**Service Letter #:** SL18 66-47200

66-47201 Side, Left, Hydraulic Pedestal

66-47400 Rudder Retract Handle

### Side Left, Hydraulic Pedestal 66-47201

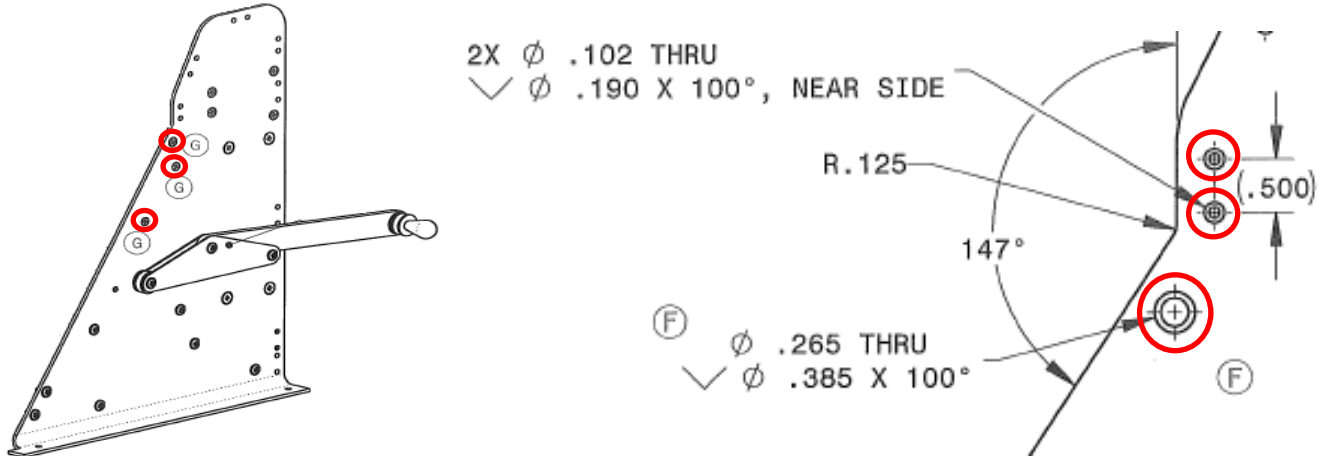
**Symptom:** Existing fasteners causing cosmetic scratches on arm of rudder retract handle and pedestal side.

1. Apply countersink to thru holes as shown

2. De-bur and apply chemical conversion coating to bare surfaces, Use Alodine 1132 Touch 'N Prep Pen or Alodine 1201.
3. Replace AN525 washer head screws with MS24694 flathead screws at 3 locations on left side.

**Corrective Action:** Replace washer head screws with countersunk type screws.

## Part 66-47400 - Rudder Retract Handle:

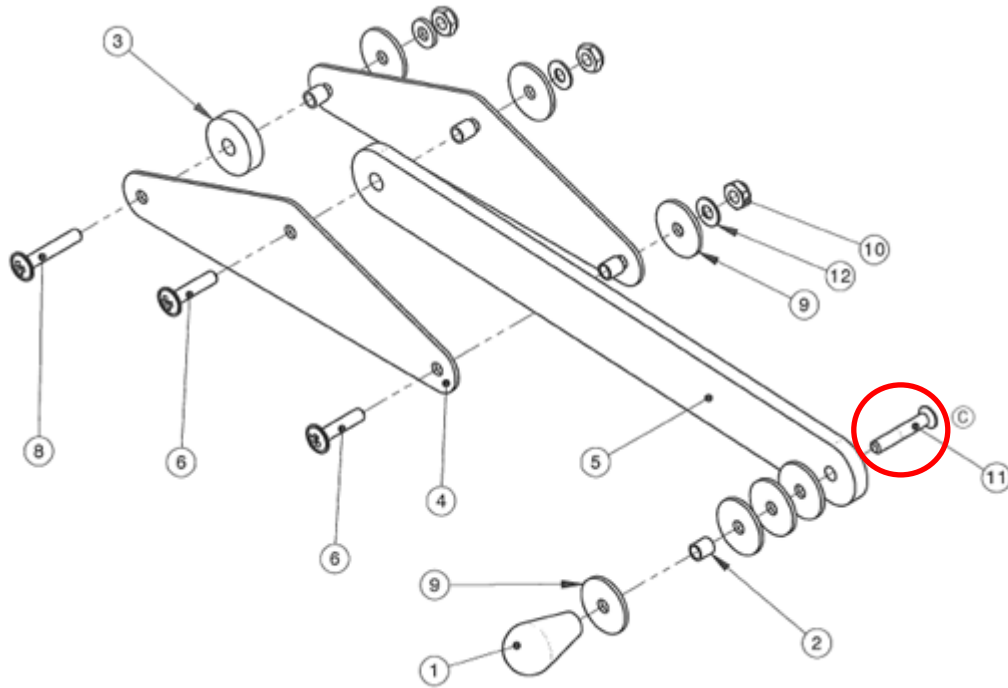
Replace washer-head screw on rudder retract handle with flathead screw.
